Request for Further LLFA Technical Input – DOC/2026/0057 (Land East of Sugar Street, Rushton Spencer)

Objection – Revised Drainage Submission – DOC/2026/0057 (Discharge of Conditions 20 and 21 pursuant to SMD/2022/0532) – Land East of Sugar Street, Rushton Spencer

01- The Proposed drainage plan by GWK Structural solutions Ltd
Drawing No GK4270-C-001 (01.03.24) amended and corrected to show assumed route of stream 31/05/2026

03 Route of stream appended by applicant to 2008 EA permit application NPSWQD001444/001 (different location to the 2025 application) with our comments noted in red

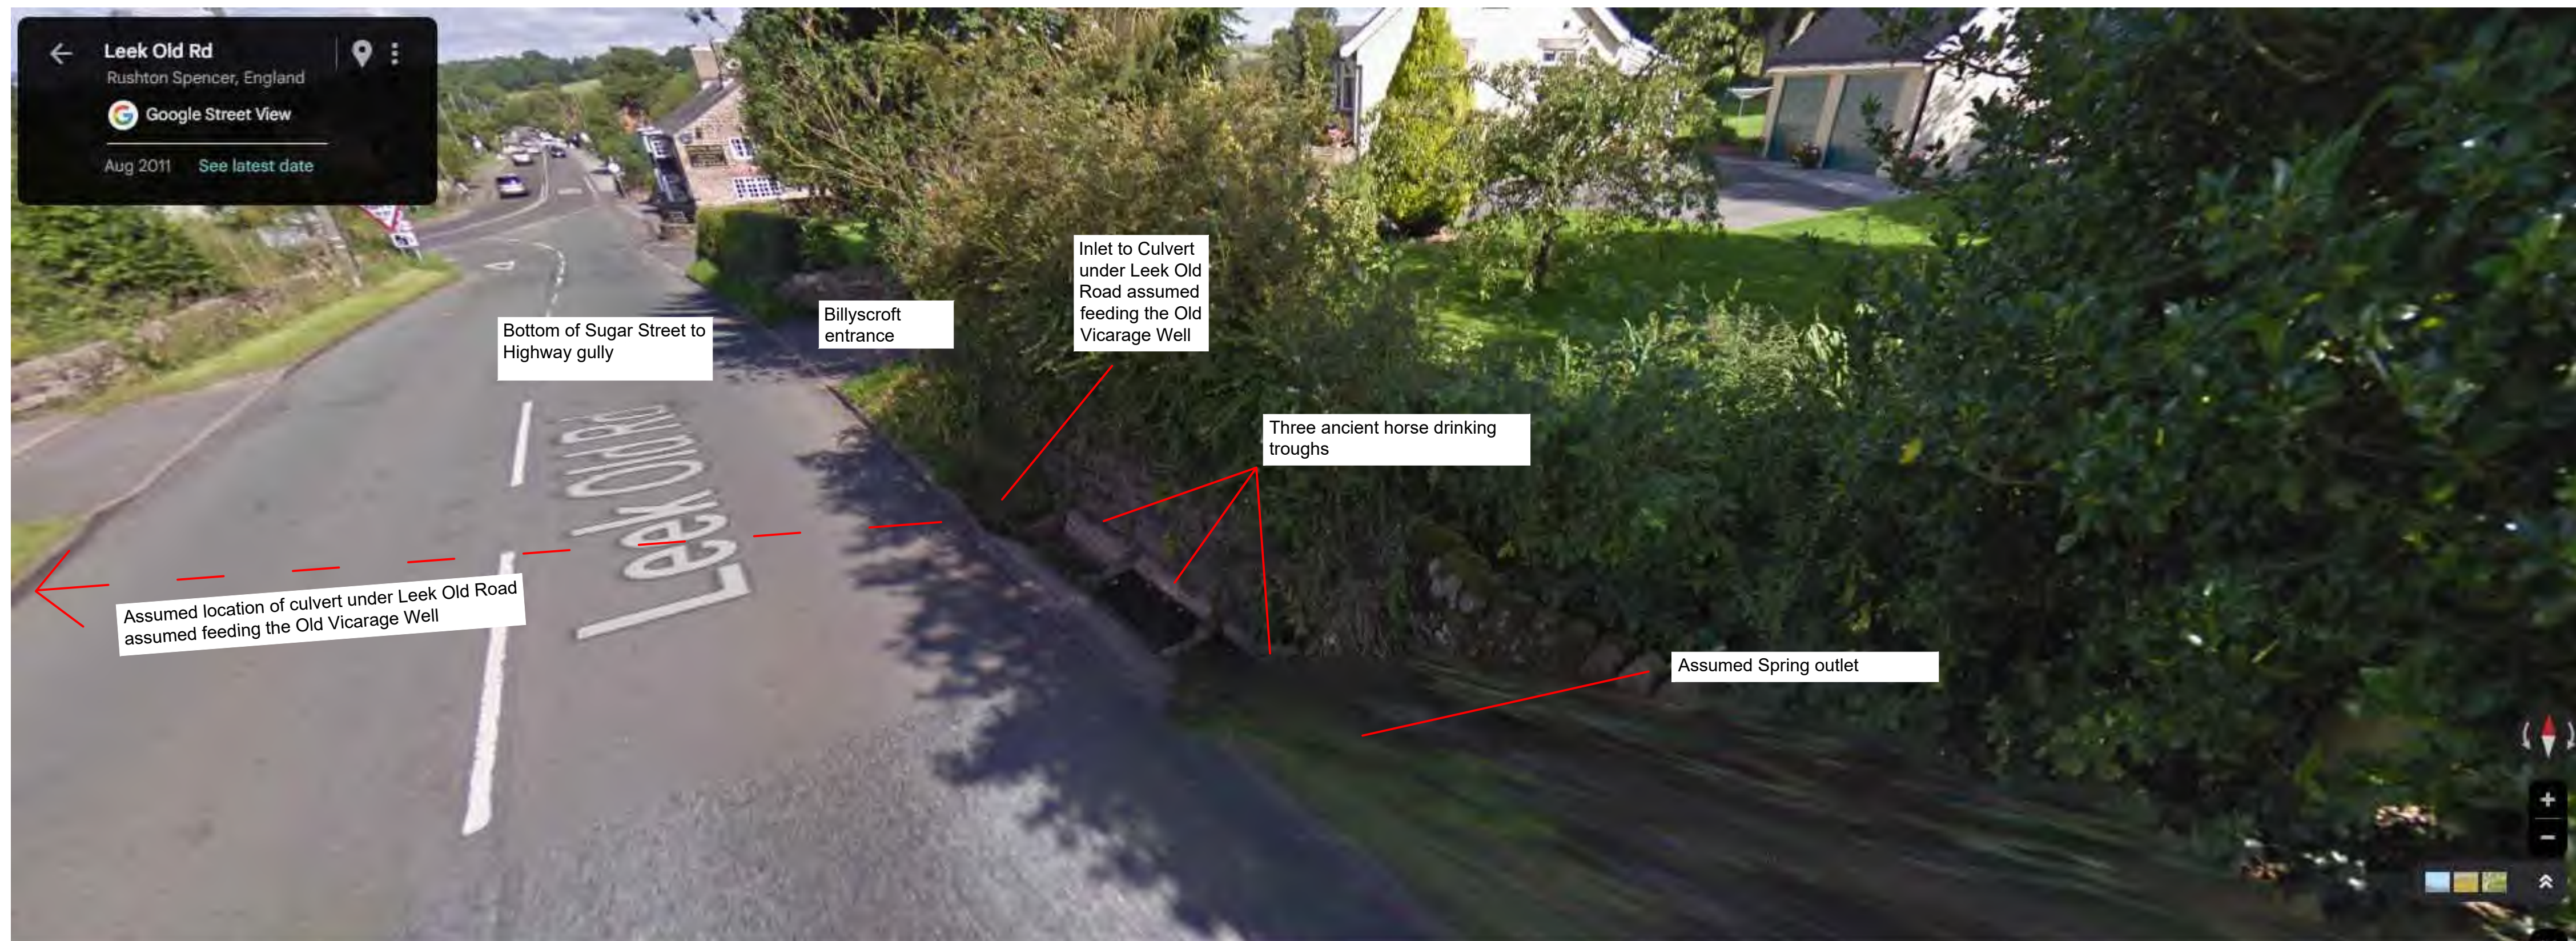
View down alley lane (view 01) field to the right slopes away from the lane. The brook does not exist in this location; this is a field with no signs of any natural ditches or surface watercourses.

Residents inform us there is no stream here, and the land is dry at all times of the year

Route of 'stream' shown on applicants' 2008 permit application route

04 Historic street views of stream / spring on Leek Old Road 2011 and 2021

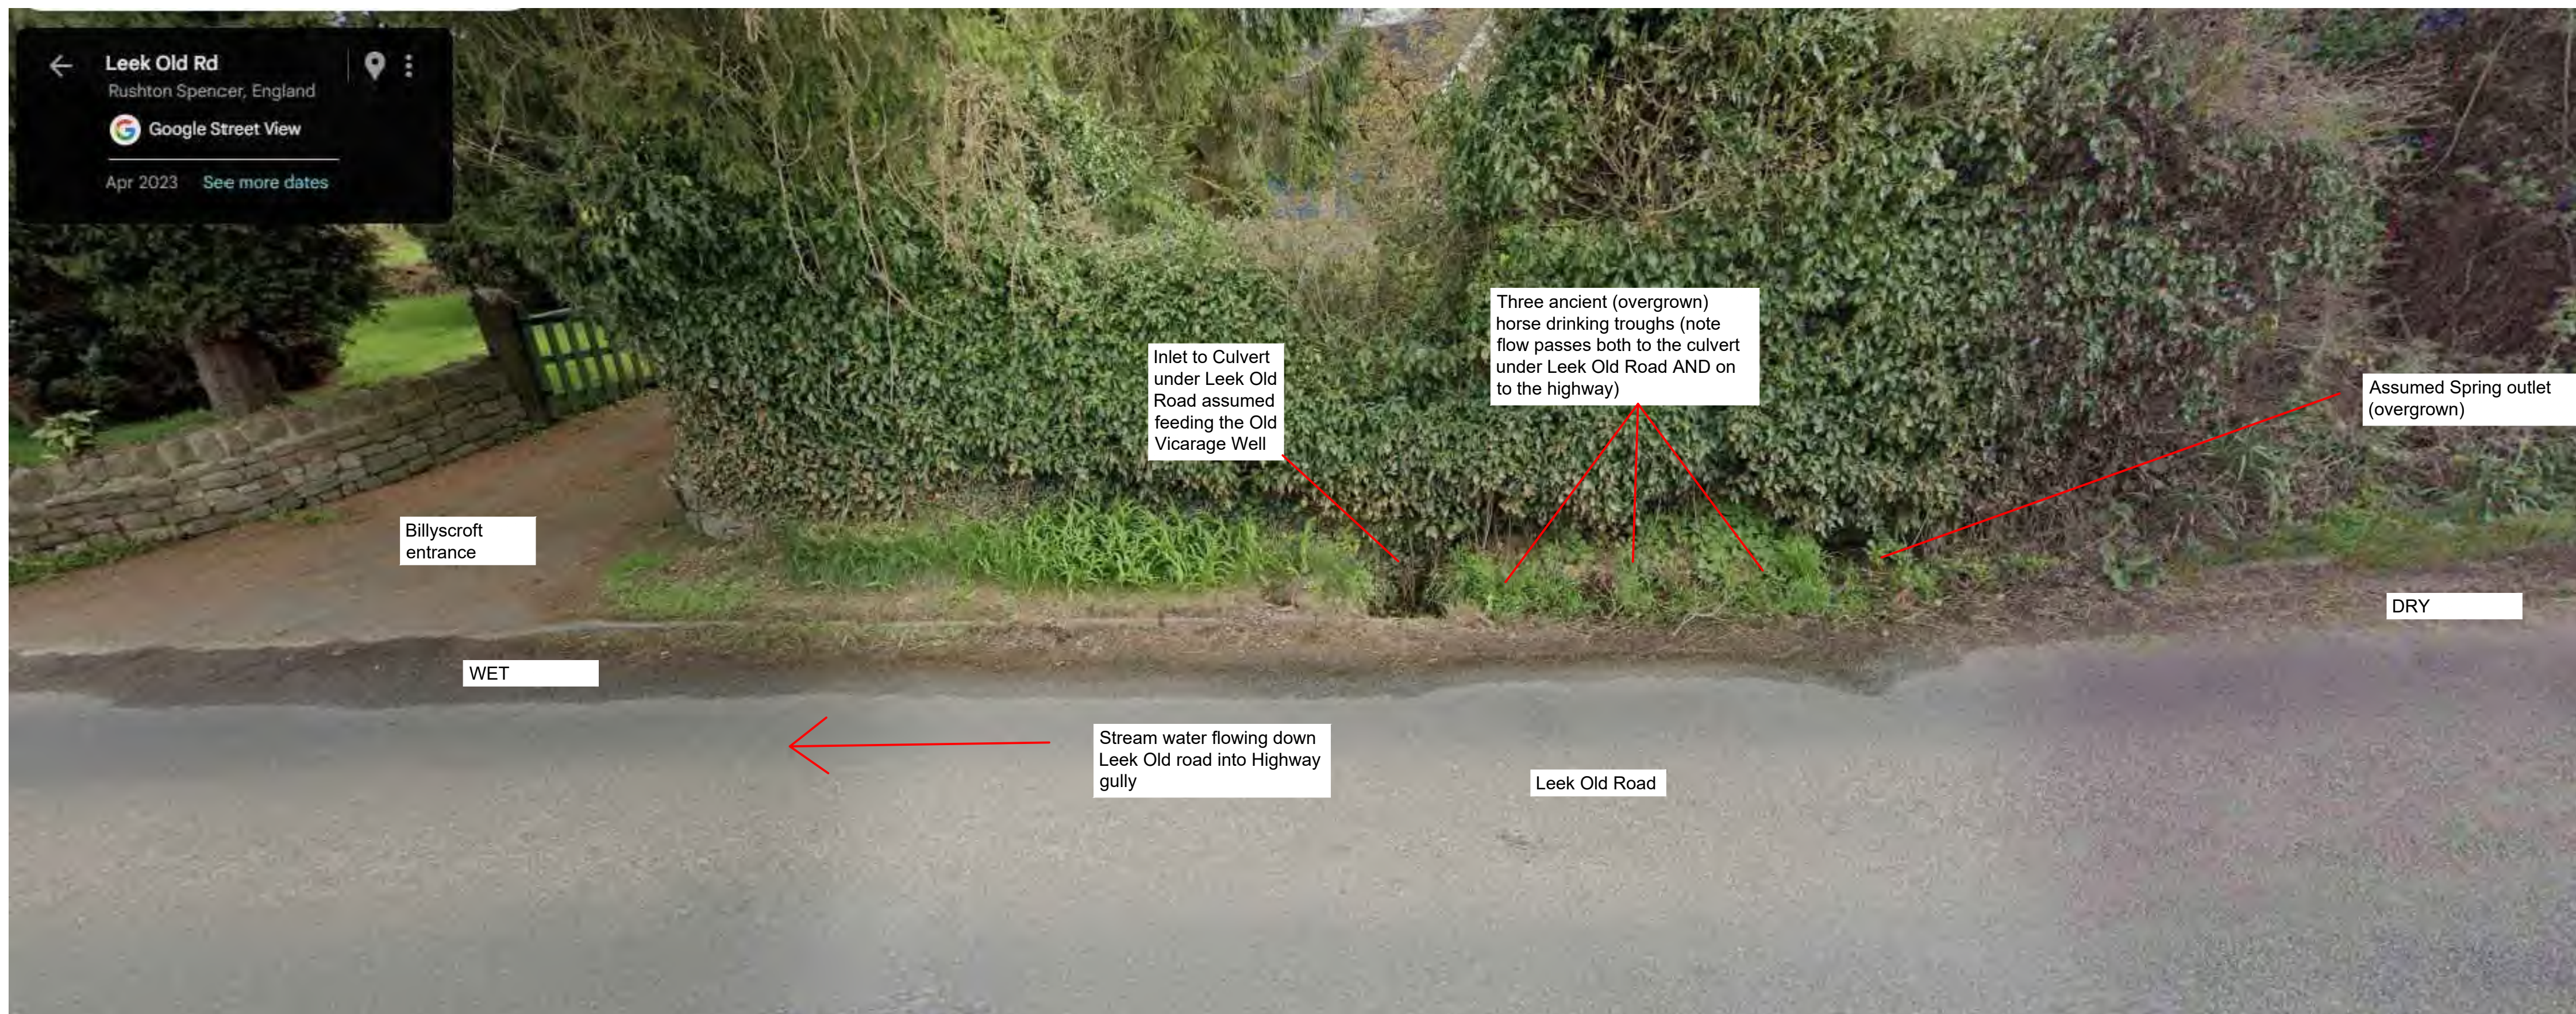
Google Street View Image August 2011

Google Street View Image April 2021

Fig 01 / View 01 Dry stone wall/ possible well-like structure at the field's low point. Is this a well, and is it hydraulically connected to the pipe and outfall?

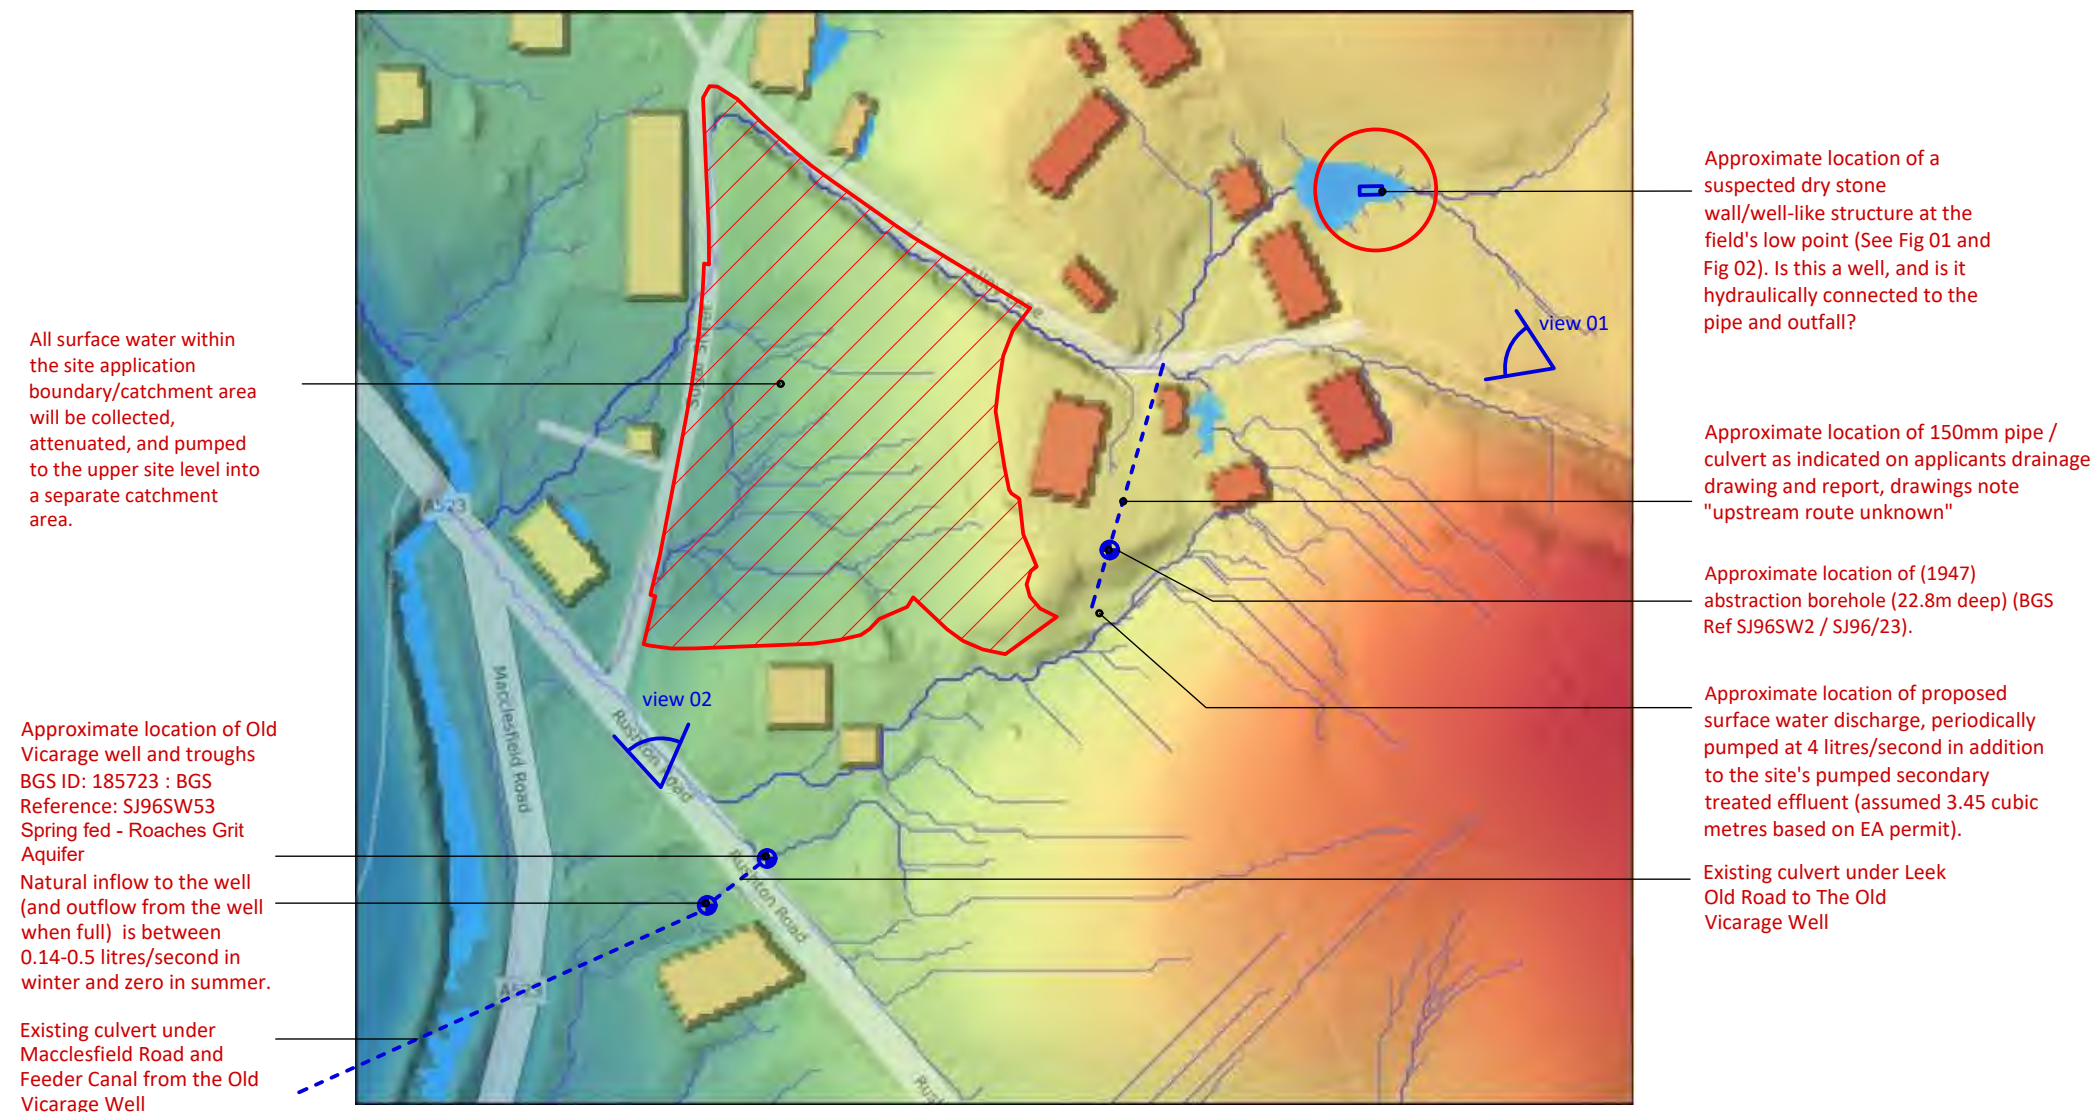
Fig 02 / View 01 Close up view of dry stone wall/ possible well-like structure at the field's low point. Is this a well, and is it hydraulically connected to the pipe and outfall?

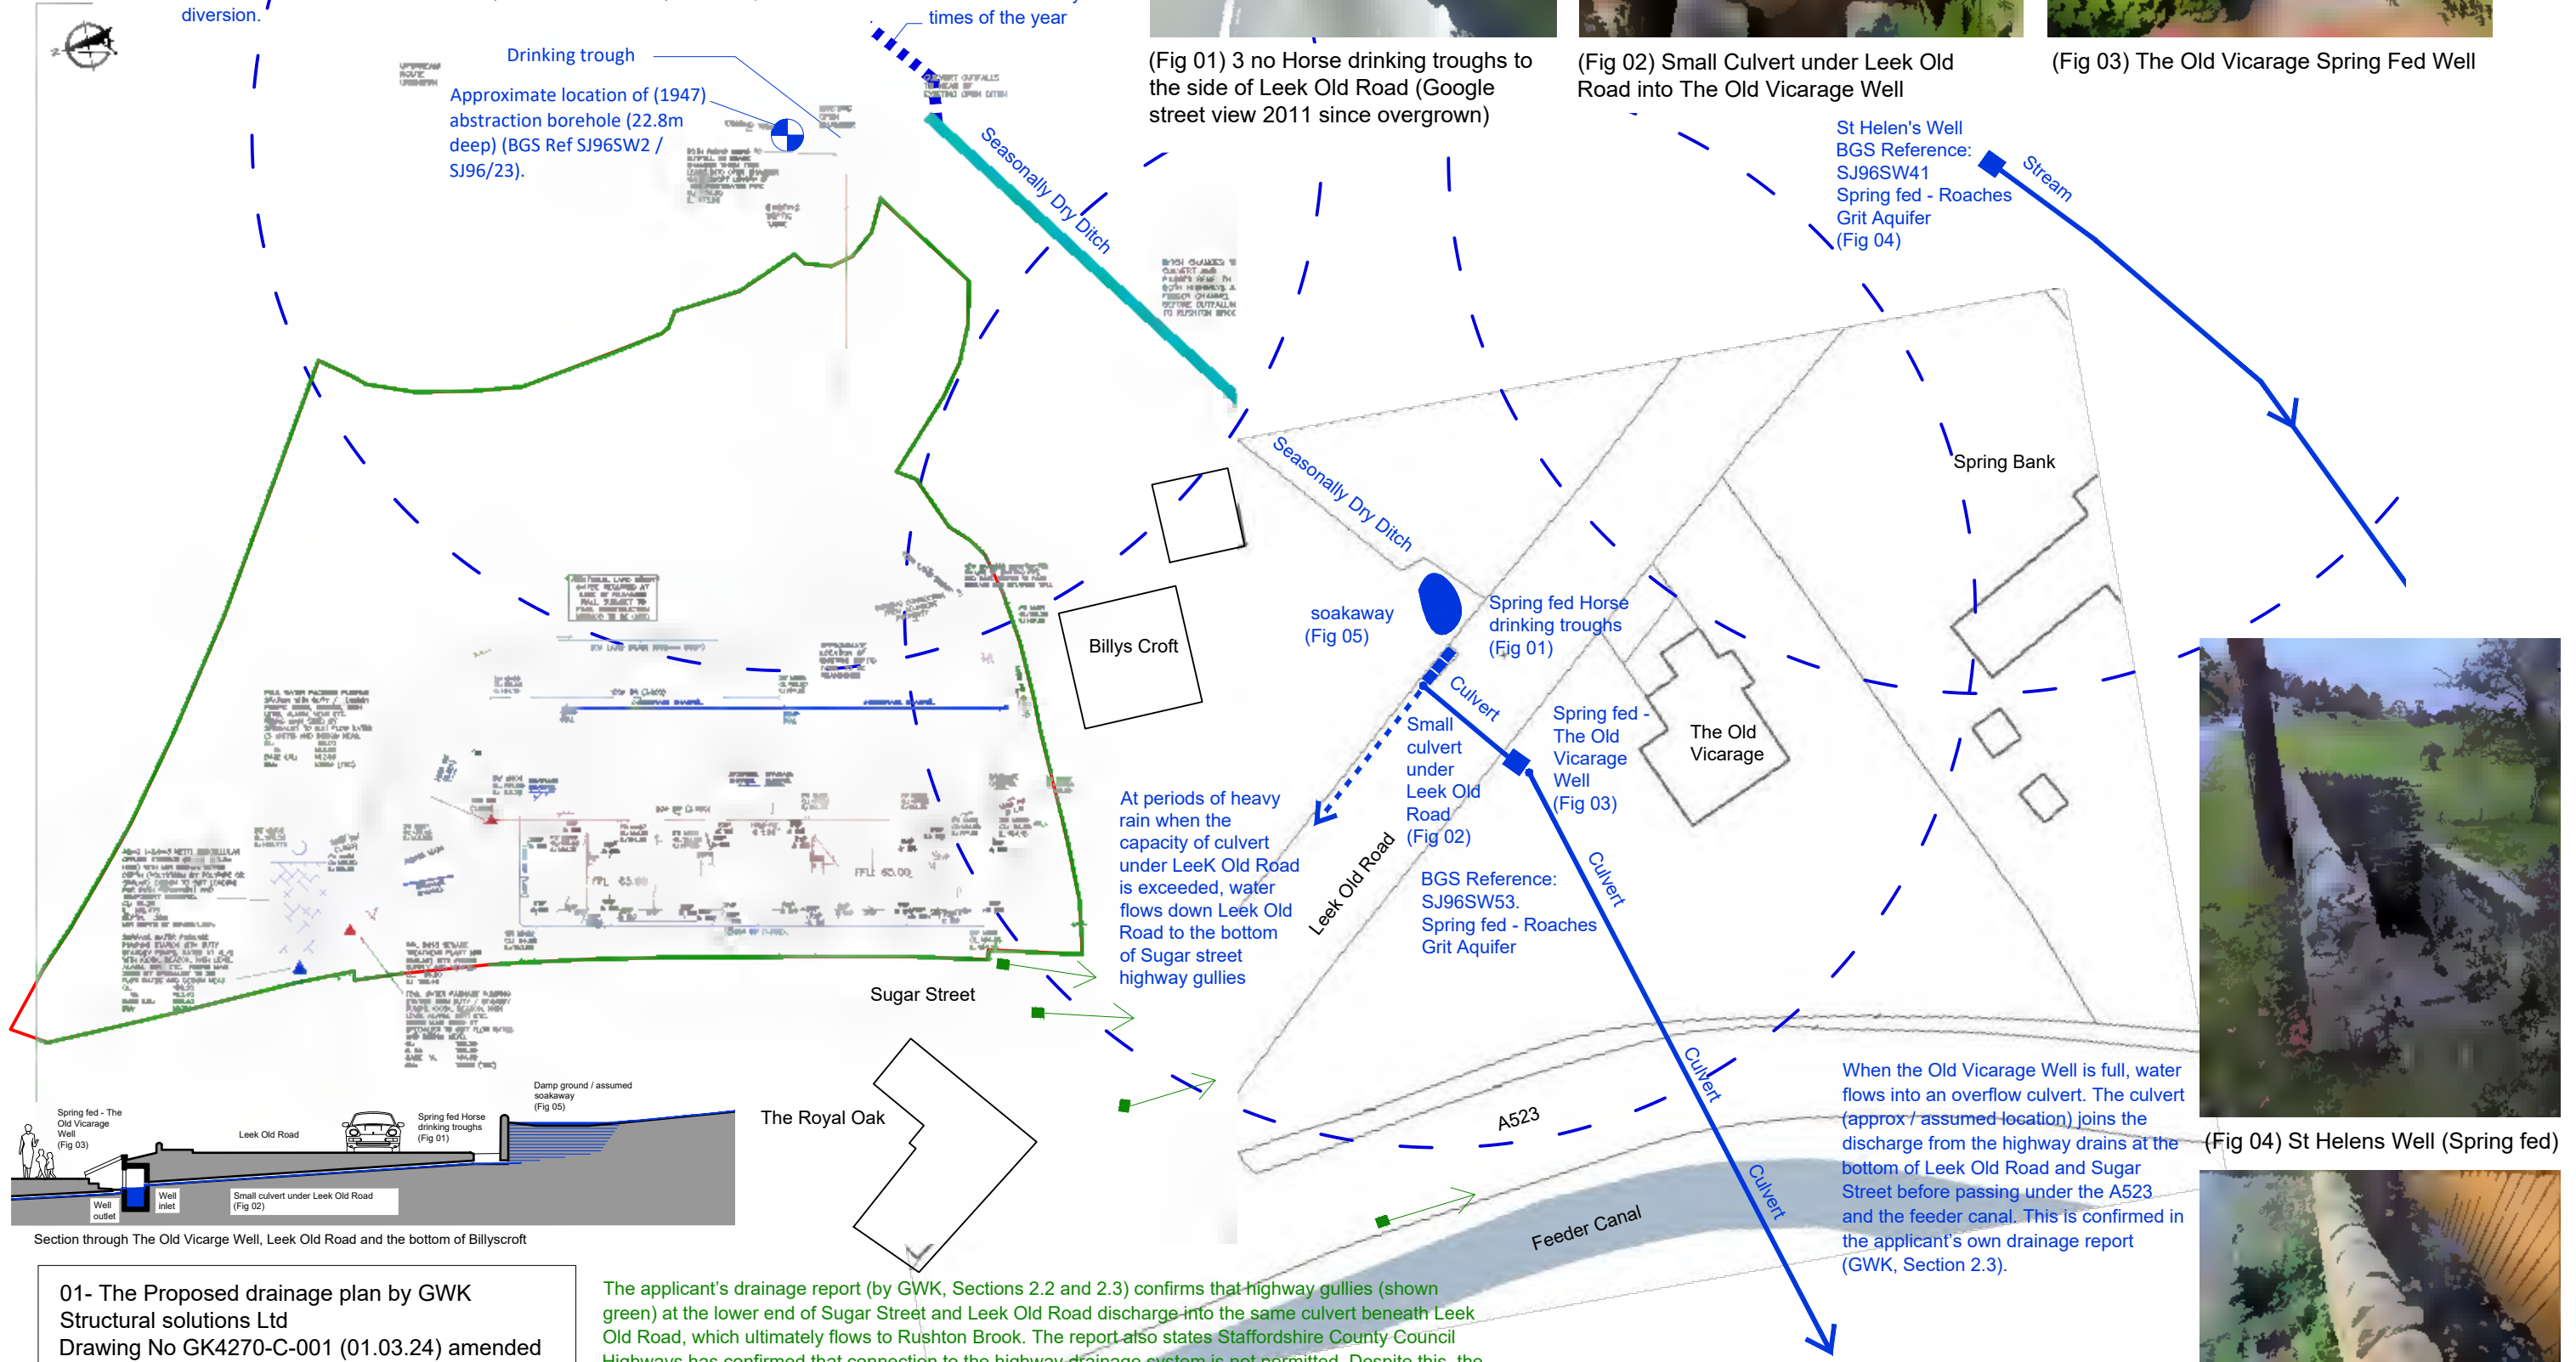
DRAWING MATERIALLY
INCORRECT AS IT
OMITS REFERENCE TO
THE PROPOSED
PARTIAL DRAINAGE
FIELD / 10m
PERFORATED PIPE
REQUIRED BY THE EA

A NOTE MATERIALLY
INCORRECT AS IT
OMITS REFERENCE
THE OLD VICARAGE
WELL, AND
HIGHWAYS DRAINS

The applicant's drainage report (by GWK, Sections 2.2 and 2.3) confirms that highway gullies (shown green) at the lower end of Sugar Street and Leek Old Road discharge into the same culvert beneath Leek Old Road, which ultimately flows to Rushton Brook. The report also states Staffordshire County Council Highways has confirmed that connection to the highway drainage system is not permitted. Despite this, the proposals show surface water and treated effluent being pumped into a ditch that flows by gravity into the same culvert system, to which the applicant has no permission to connect.

At periods of heavy
rain when the
capacity of culvert
under Leek Old Road
is exceeded, water
flows down Leek Old
Road to the bottom of
Sugar street
highway gullies

When the Old Vicarage Well is full, water flows into an overflow culvert. The culvert (approx / assumed location) joins the discharge from the highway drains at the bottom of Leek Old Road and Sugar Street before passing under the A523 and the feeder canal. This is confirmed in the applicant's own drainage report (GWK, Section 2.3).
